45 The Vineyard Planning Changes

Date: August 2024
Doc No. 5008

Revision G

Since activating the planning permission (ref 19/0954/VRC) the scheme has undergone both a stage 3 design review and stage 4 design development. This document seeks to present the design updates with a view to substituting the existing planning drawings with an updated set to maintain the completeness of the consent, for the avoidance of doubt and in the interests of proper planning. The design updates have been made for the following reasons:

Drawing Title:
ROOF PLAN PROPOSED

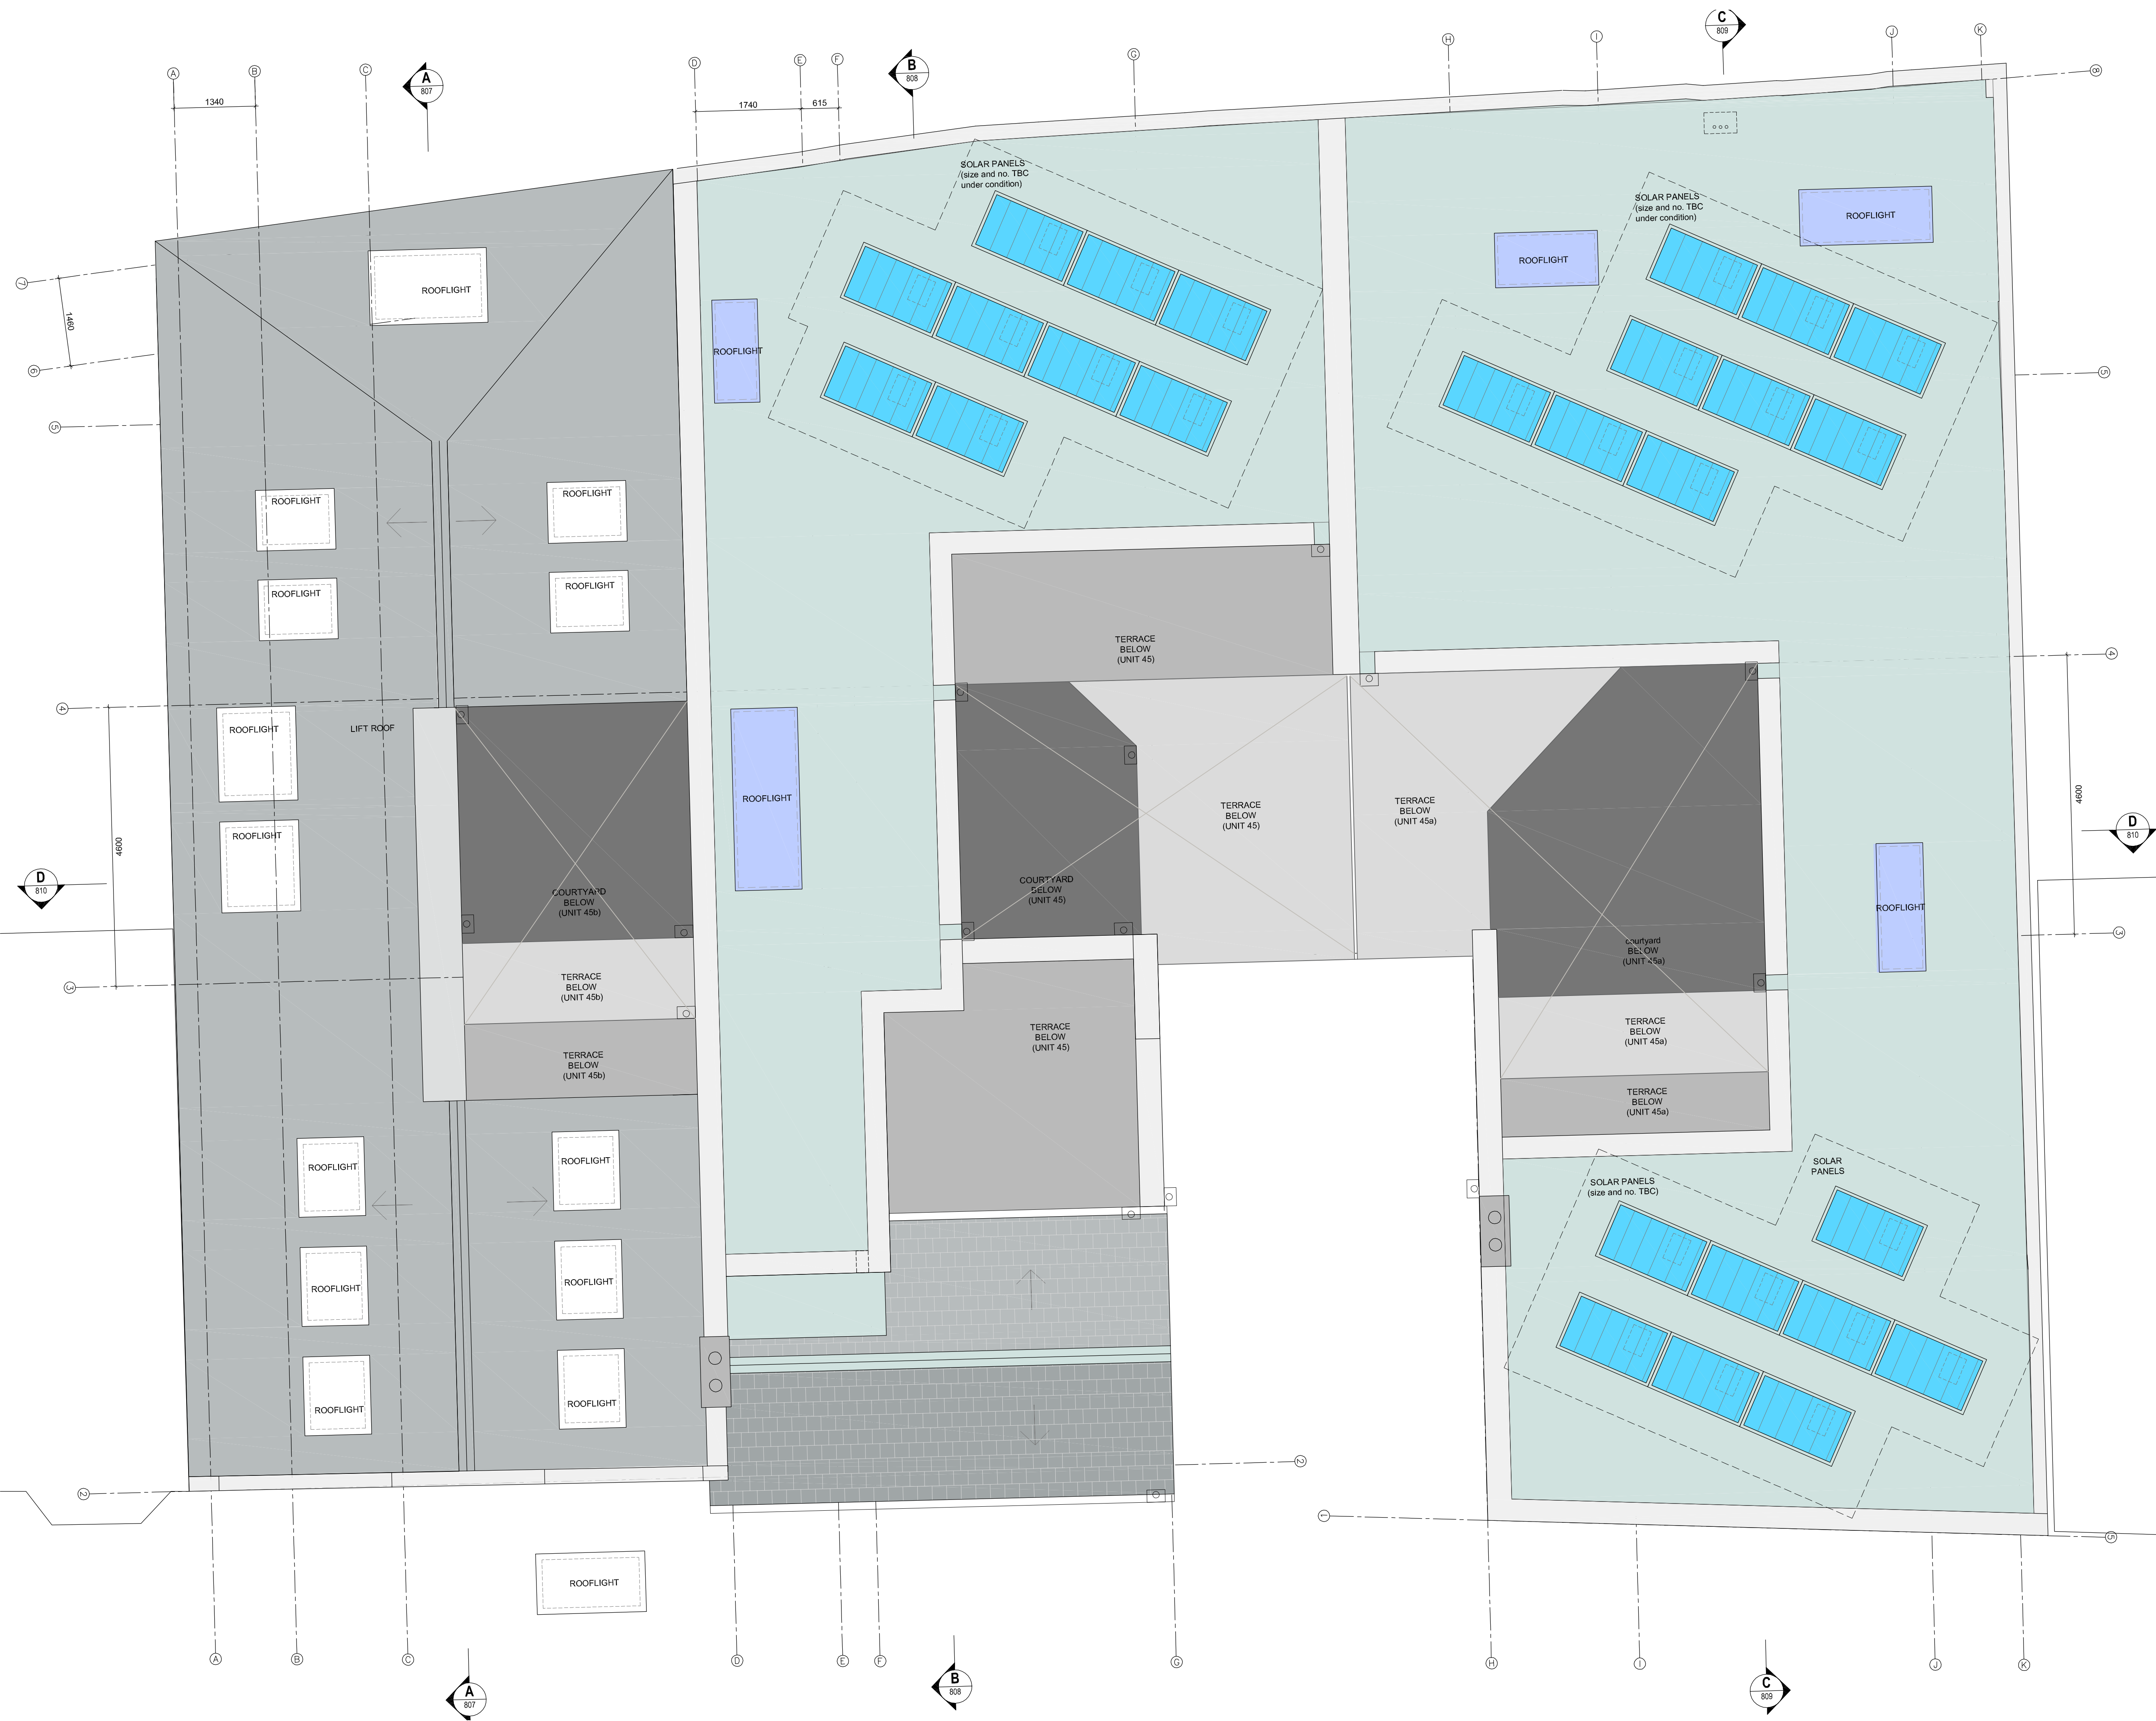
The green roofs are not required for attenuation (the site is currently fully hard roofed) and the inclusion of the photovoltaic panels, as required by Condition U0070611, has meant that the extent available for green roof renders them unviable. They have therefore been omitted.

The photovoltaic panels proposed for the roof are now shown on the roof plan, although the final details (size, number and configuration) will be confirmed through the discharge of the relevant planning conditions. It is intended, subject to detail design, to provide sufficient for the supply of 2Kwh per unit as a minimum.
